PROJECT OVERVIEW

COMPOSITE SITE PLAN | Site Plan

RESPONSE TO EARLY DESIGN GUIDANCE

COMPLIANCE DIAGRAMS - BLANK FACADE

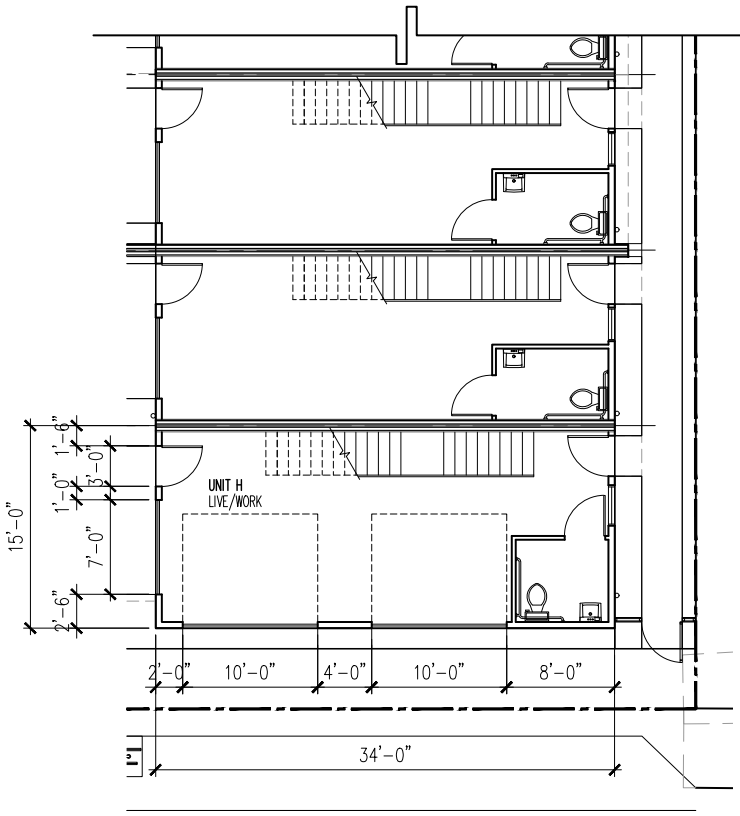
Departure #1:
23.47.008.A.2.c: The total of all blank facades may not exceed 40% of the width of the façade of the structure along the street.
4/G2.00: North Building, Unit H: The proposed indicates a blank façade of 41.2%. This equates to 4.8” over allowable blank façade. The rationale is material dimensions and building repetition and rhythm. The proposed façade includes two garage doors each 10’ in width. A door could be special ordered of a different width to meet blank facade requirements if necessary. This would then likely dictate another special-order door to maintain symmetry. The two doors maintain the repetition present through the design and provide a pleasing rhythm along this façade. In addition, the main floor utilizes masonry providing a pleasing highly textured façade where facades are deemed blank.

The code requires non-residential uses (live/work units) blank segments of the street-facing facade between 2 feet and 8 feet above the sidewalk may not exceed 20 feet in width, and the total of all blank facade segments to not exceed 40 percent of the width of the facade of the structure along the street.

Proposed blank façade live/work north building:
Total façade length: 34'-0"
Total blank façade length: 14'-0"
% Blank façade: 41.2%

While it is feasible to obtain 40% maximum blank facade by the additional 4 13/16" this would require a custom opening. It is preferred to proceed with standard sized doors to maintain the rhythm created by the equal sized openings. While not street facing this particular live work unit is also providing transparency along the south facade perpendicular and visible from airport way and a component of the courtyard. This design strategy provides over 60% transparency on both facades accessible and visible to the public and allows for standard door widths and interior programmatic requirements. I.e. the required accessible bathroom.
